TECHNICAL SERVICE BULLETIN

Front Window Glass Jumps/Chatters During Up/Down Travel

19-2050
25 February
2019

Ford 2016-2017 Explorer

Figure 1

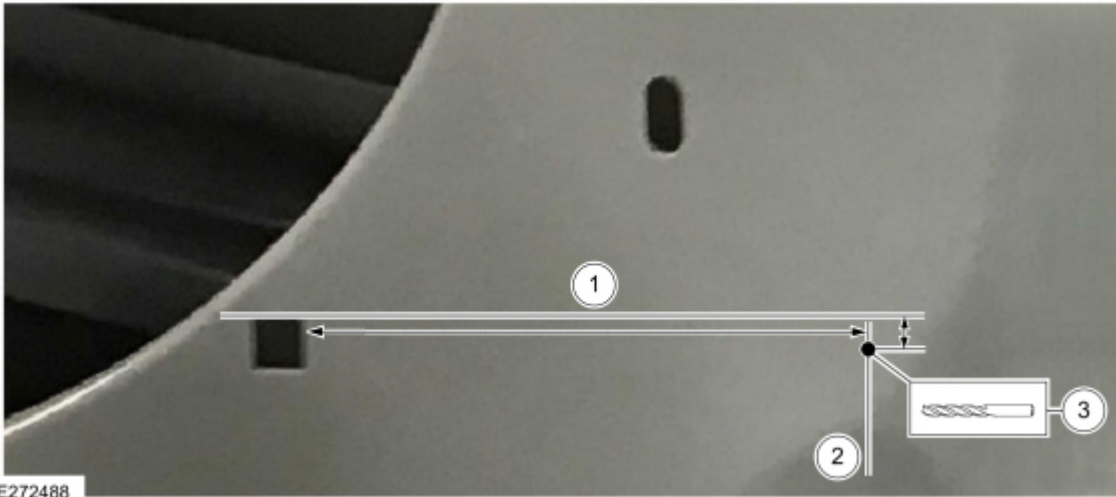
- (1). Place a ruler horizontally along the top edge of square hole shown in Figure 1 draw a line 65 mm (2.5 inch) long. Refer to Figure 2 Callout 1. (Figures 1-2)

- (2). Measure 46 mm (1.8 inch) from the door latch side edge of the square hole and place a vertical mark at the intersection of the horizontal line drawn in Step 5(1). (Figure 2 Callout 2)

- (3). Measure down 2 mm (0.08 inch) from the horizontal line along the vertical line and place a mark. (Figure 2 Callout 3)
 - (4). Place a centering mark at the location marked in Step 5(3) using a hammer and center punch and drill a 9 mm (0.35 inch) diameter hole.

Figure 3

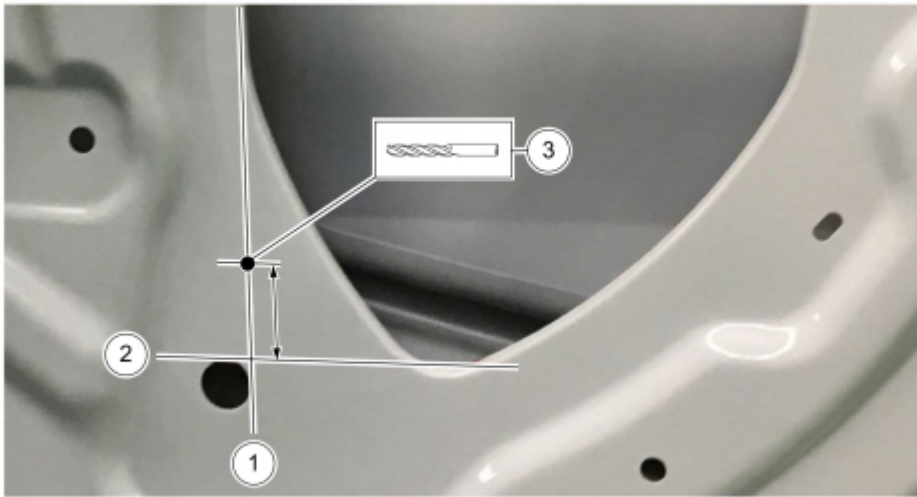
- (1). Place a straight edge vertically along the edge of the large stamped regulator access opening in the door on the door hinge side of the opening and draw a line that extends to the bottom of the stamped opening. (Figure 3)
- (2). Place the straight edge horizontally along the lowest point of the stamped opening and across the top of the round hole towards the door hinge side of the door and draw a line between the bottom of the stamped opening and the hole. (Figure 4 Callout 2)
- (3). Measure up 32 mm (1.25 inch) from the horizontal line along the vertical line and place a centering mark using a center punch and hammer. (Figure 4)
- (4). Drill a 6.5 mm (0.25 inch) diameter hole. (Figure 4 Callout 3)
- (5). Apply Motorcraft® Anti-Corrosion Coating to all drilled holes.

Figure 5

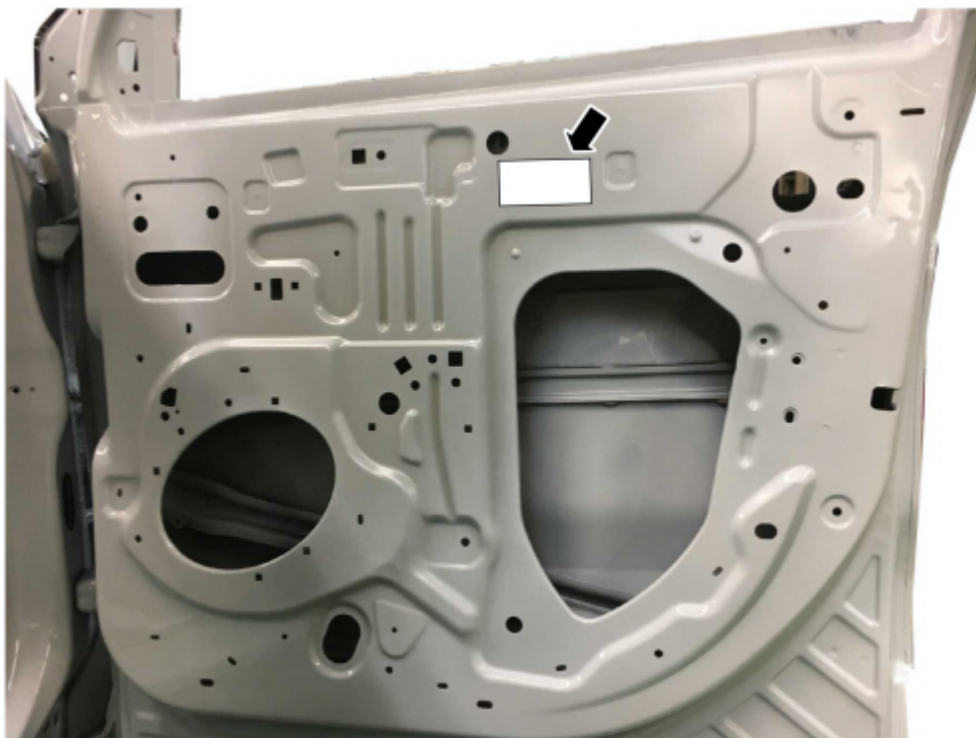
(2). Attach the information label to the door sheet metal above the window regulator access opening using clear packaging tape completely covering the label with tape. (Figure 5)
